REPORT TO SHASTA COUNTY BOARD OF SUPERVISORS

SUBJECT	<u>PUBLIC HEARING</u>	BOARD MEETING DATE 11/04/2008	AGENDA NUMBER
APPEAL OF PLANNING COMMISSION APPROVAL OF USE PERMIT 06-016 (HATCHET RIDGE WIND LLC) BURNLEY AREA			
DEPARTMENT	RESOURCE MANAGEMENT PLANNING DIVISION	SUPERVISORIAL DISTRICT NO.: 3	
DEPARTMENT CONTACT:	<u>Name</u> Russ Mull	<u>Title</u> Director	<u>Phone Number</u> 225-5789
4/5 Vote Required? <input type="checkbox"/> Yes <input checked="" type="checkbox"/> No	General Fund Impact? <input checked="" type="checkbox"/> No General Fund Impact with the Recommended Action <input type="checkbox"/> No Additional General Fund Impact from the Recommended Action <input type="checkbox"/> General Fund Impact from the Recommended Action

ATTACHMENT 9
SITE PLAN
USE PERMIT 06-016
HATCHET RIDGE WIND
BURNEY AREA

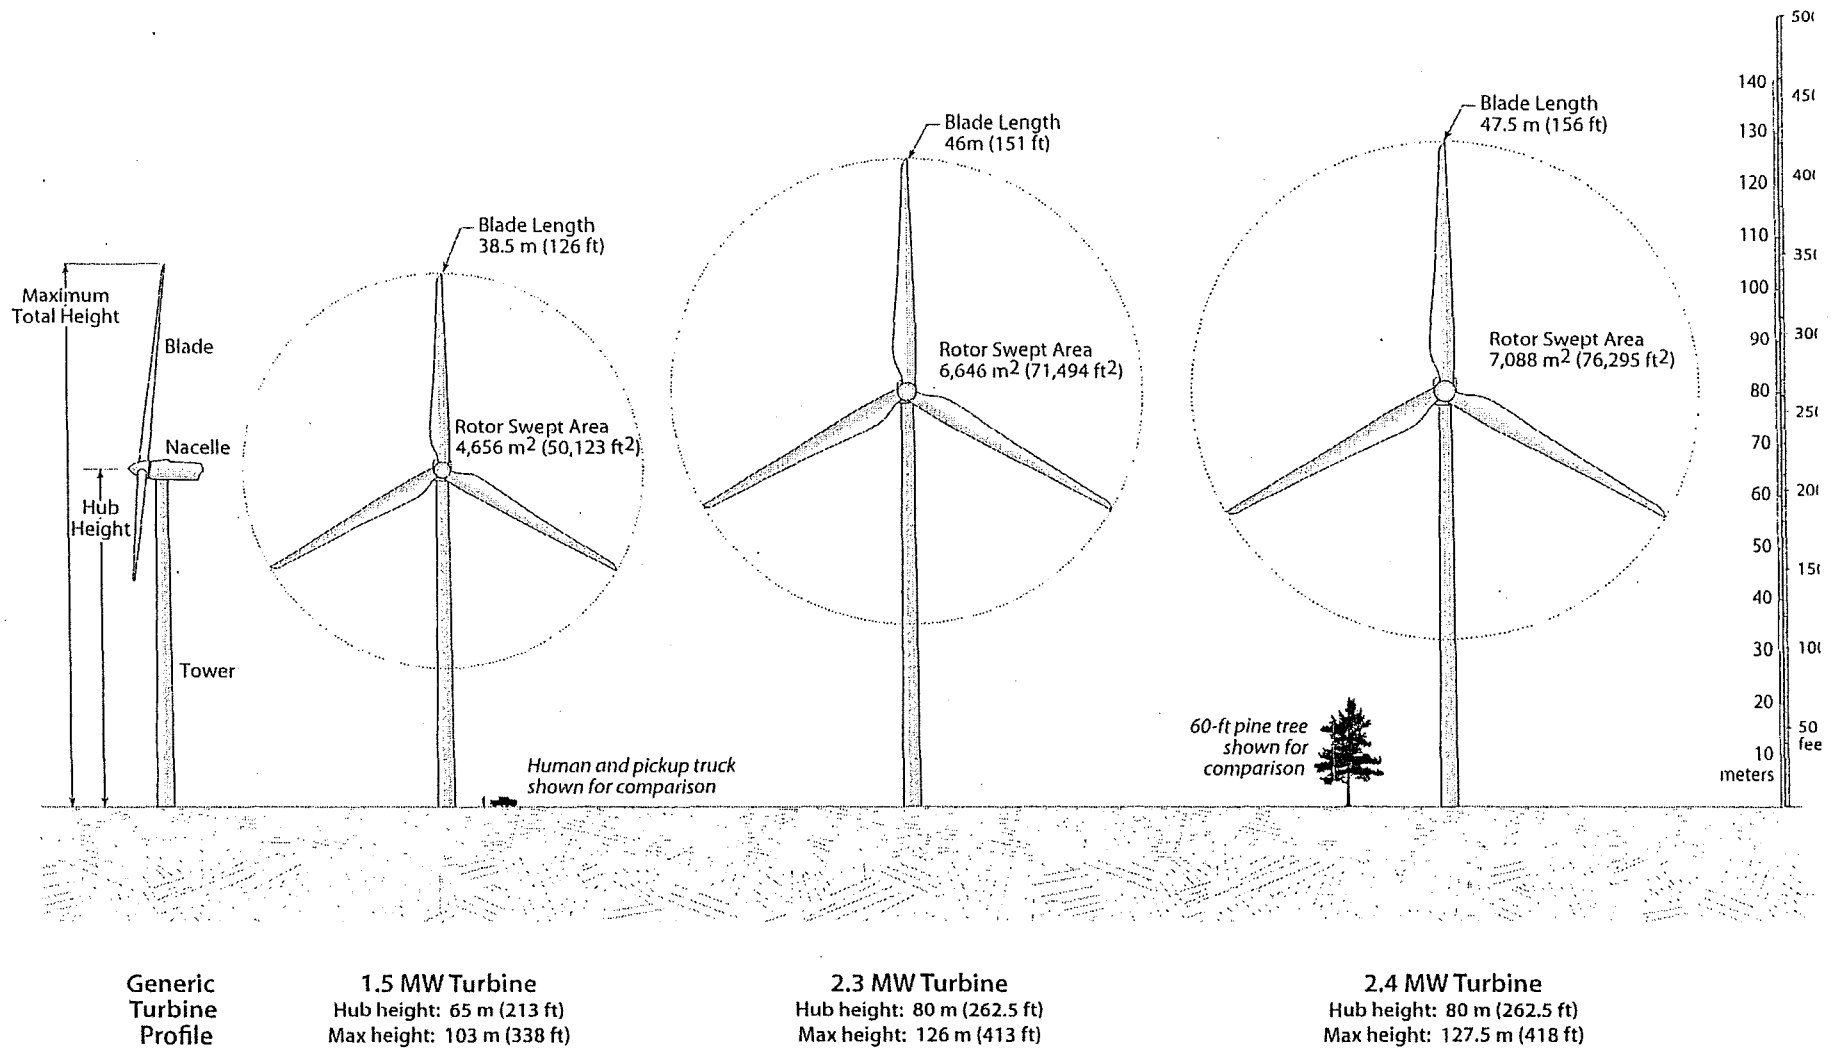
In this portion of the appeal, we request that the inter-tower spacing parameters shown on the topographic map, 06-Fig 2-1.pdf, be changed. The following documents from knowledgeable sources reliably demonstrate that this change can be accomplished with minimal change to project efficiency.

If the Department of Resource Management modifies the use permit to require re-spacing the turbine towers to a location out of public view, the developers will gain a clearly superior wind plant location and Shasta County will benefit from future years of unmarred scenic beauty.

The appellant requests that the Dept of Resource Management modify the CUP "to require re-spacing the turbine towers to a location out of public view" and claim that by doing so, "the developers will gain a clearly superior wind plant location." (Save Burney's Skyline Appeal, p. 8.)

Response: The appellant has provided general information from a variety of sources on wind power history, turbine interactions with wind flow, land area requirements for wind farms, wake analysis, and wind acceleration over ridge lines, and suggests that based on this information there is enough flexibility regarding turbine placement that the turbines associated specifically with this project could be relocated "out of direct public view." However, the appeal lacks project- or site-specific data to support this position or to discredit the analyses in the Environmental Impact Report (EIR) and other documents in the record, that acknowledge there is some flexibility regarding placement, albeit limited, but that moving the turbines enough to eliminate visual impacts from Burney would be technically and economically infeasible.

minimum turbine spacing is required by turbine manufacturers in order to secure a turbine warranty. For the Hatchet Ridge Wind Project, turbine manufacturers require minimum spacing of 2.5 – 3.0 times the turbine rotor diameter (238 – 285 meters; 779 – 935 feet) for turbines within the same row and approximately 7.5 times the turbine rotor diameter (713 meters; 2335 feet; .44 miles) between turbine rows. These constraints provide virtually no flexibility for maintaining Project size and the associated economies of scale. Relocation of turbines will disrupt the current Project layout, reduce overall Project size and severely harm Project economics.
